NOTICE OF VIOLATION

On October 24, 2023, Energy Safety conducted an inspection of Bear Valley Electric Service, Inc.'s WMP initiatives in the vicinity of the city of Big Bear Lake, California. The inspection report is enclosed herewith. Energy safety found the following violation:

INSPECTION REPORT

Electrical Corporation:	Bear Valley Electric Service, Inc. (BVES)				
Report Number:	BVES_CAC14_20231024_0818				
Inspector:	CAC15				
WMP Year Inspected:	2023				
Quarterly Data Report (QDR) Referenced:	Quarter 2 (Q2)				
Inspection Selection:	Energy Safety viewed the contents of the Q2 QDR and performed an analysis that resulted in the selection of				
	the WMP initiatives and locations referenced in this report.				
Relevant WMP Initiative(s):	Clearance (2023 WMP initiative number 8.2.3.3)				
Date of inspection:	October 24, 2023				
City and/or County of Inspection:	Big Bear Lake, San Bernardino County				
Inspection Purpose:	Assess the accuracy of Bear Valley Electric Service, Inc.'s QDR data, completeness of its work, compliance with				
	WMP requirements, and compliance with its protocols.

Structure ID: IR3469

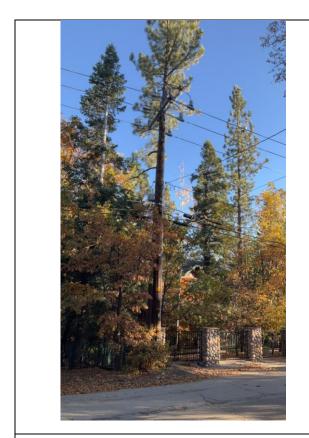
Near pole ID IR3469 at 42128 Switzerland Dr, Big Bear Lake, CA, 92315, USA, 34.2372390327414, -116.883346825071, the inspector observed that vegetation was growing within the 72-inch safe clearance distance under primary covered conductors. The inspector's observation is documented in Violation 1 photographs, which are attachments to this report. Photo numbers Item1IA1Img1 and Item1IA1Img2 depict a tulip tree growing approximately six feet under primary covered conductors.

- 1. The goal of Bear Valley Electric Service, Inc.'s Initiative 8.2.3.3 Clearance is to proactively maintain vegetation, so it does not contact electrical infrastructure, thereby preventing wildfires.
- 2. The tulip tree is not in contact with covered conductor, but within Bear Valley Electric Service, Inc.'s minimum 72-inch safe clearance distance around primary conductors.
- 3. Bear Valley Electric Service, Inc.'s WMP clearance work was identified as complete at this location.
